## Aguilar Addition

10341 NE 141st Pl  
Kirkland WA 98034

**8.31.2023/Post Rev 1 - Move lower unit entry door, window sized changed, upper unit entry door moved, revise wall framing and hold down location for revised entry openings, revised framing and beam sizes, reduced overhang and revised support of added studs at post.**

# INSERT REVISED PAGES INTO APPROVED SET 08/31/2023

Photo 1. Retaining this Douglas fir tree satisfies the canopy retention credit requirements.

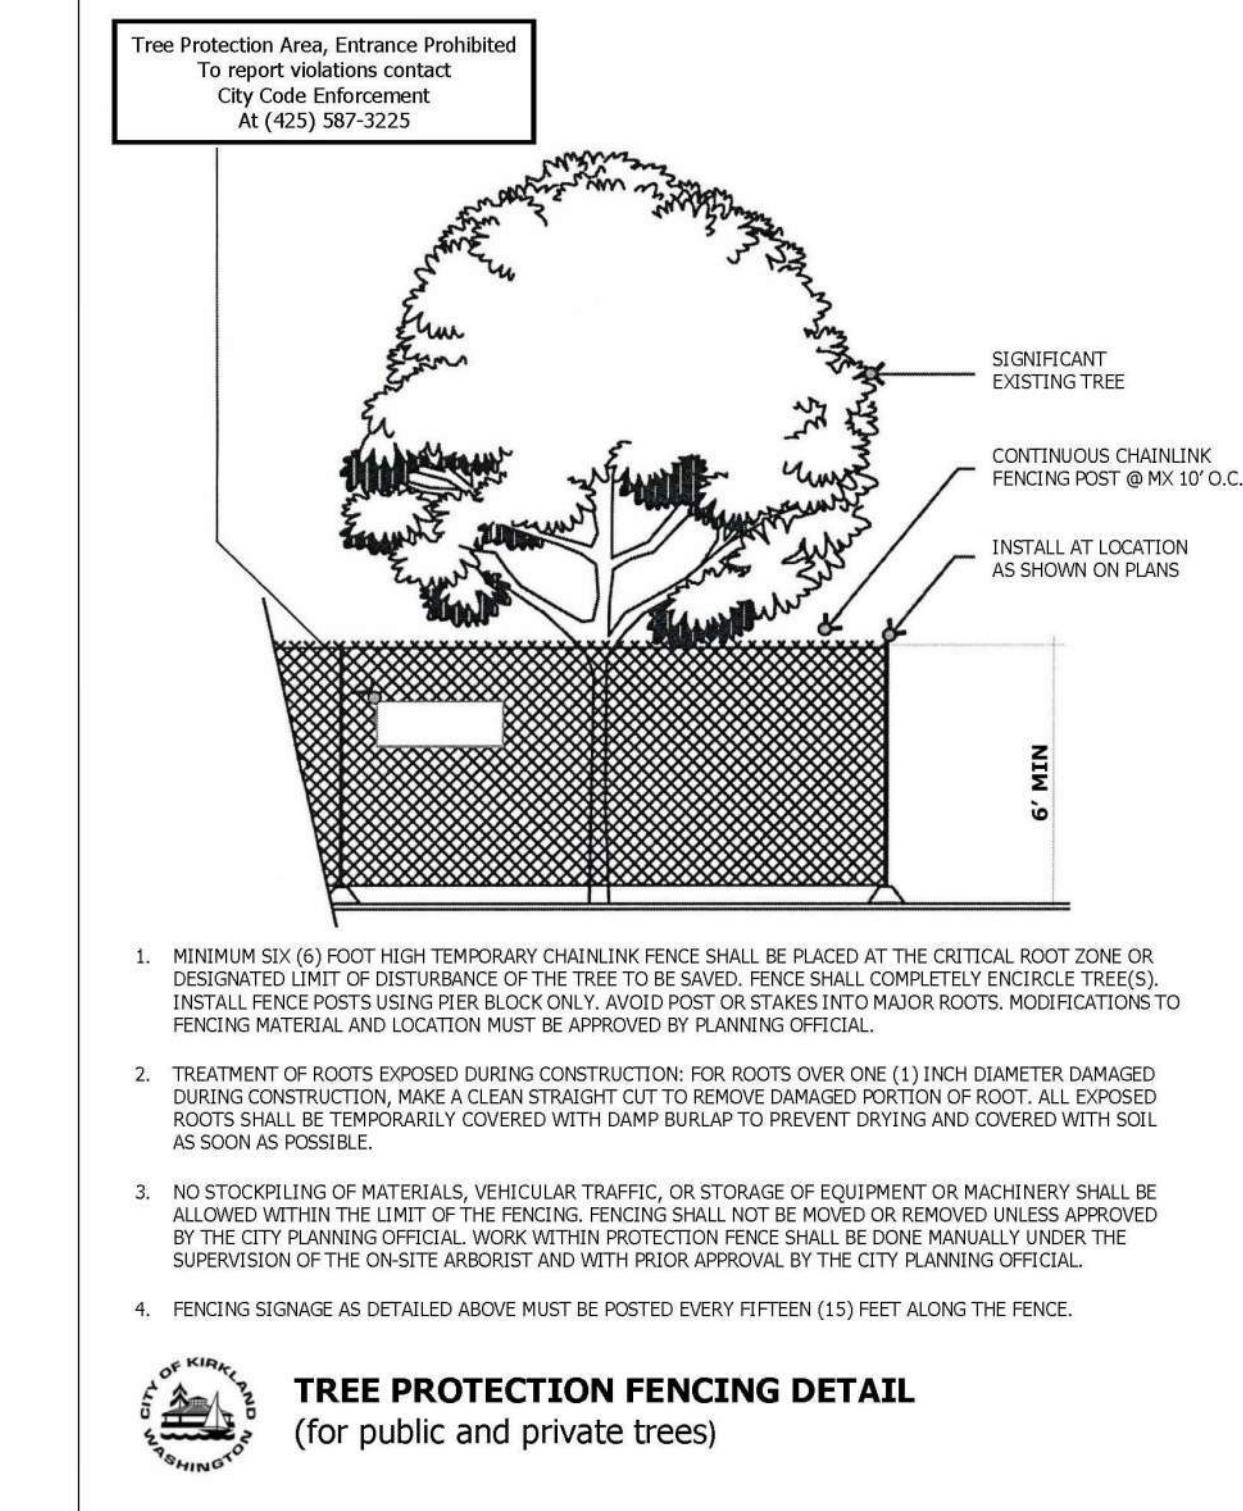
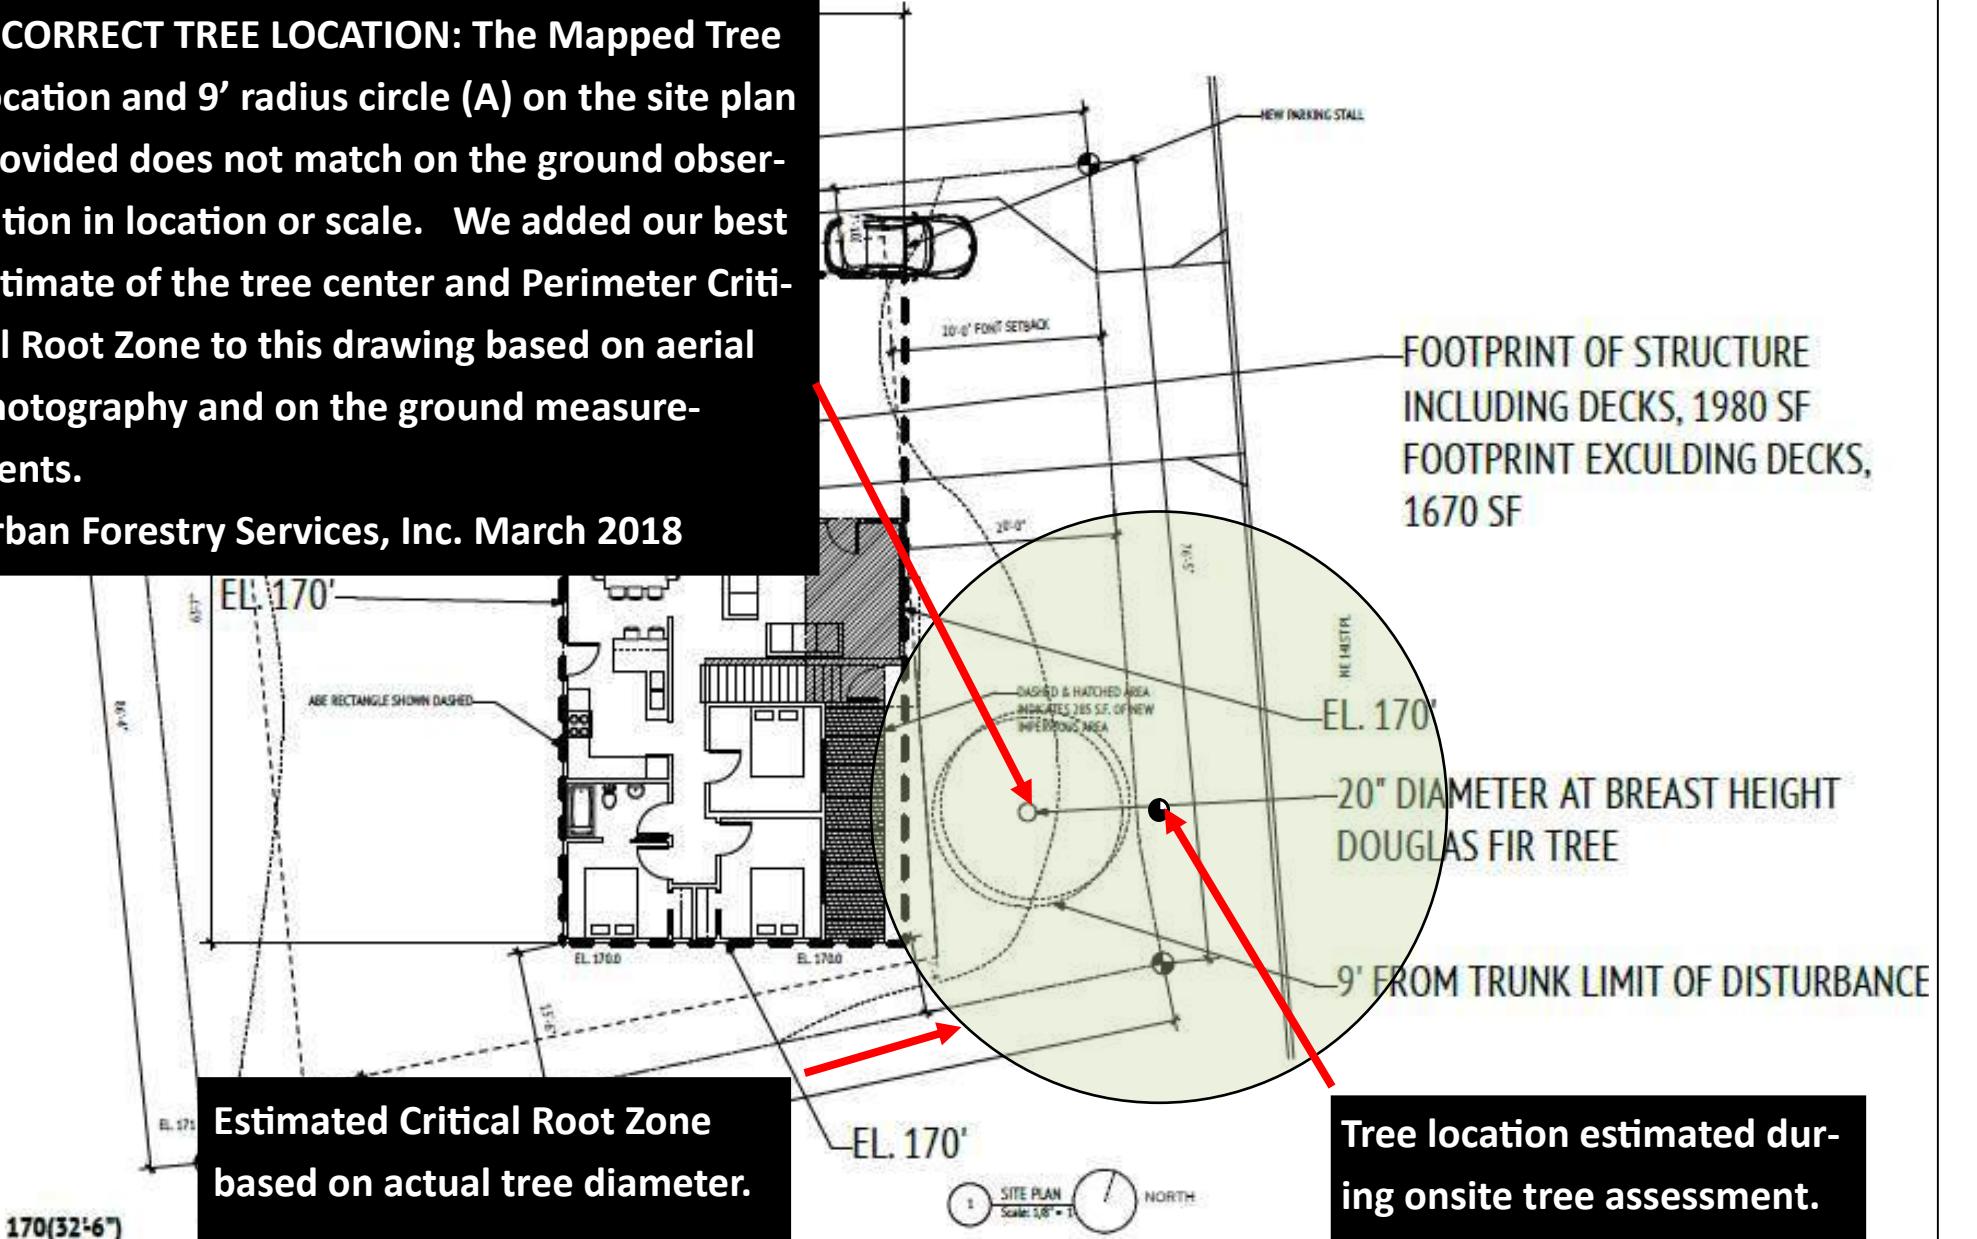
INCORRECT TREE LOCATION: The Mapped Tree Location and 9' radius circle (A) on the site plan provided does not match on the ground observation in location or scale. We added our best estimate of the tree center and Perimeter Critical Root Zone to this drawing based on aerial photography and on the ground measurements.

This report and recommendations should fulfill the arborist report component for the City of Kirkland Major Tree Retention Plan requirements. The tree is located 29.5 from the house. Its location should be correctly shown on the plans prior to drawing in the Perimeter and Interior CRZ.
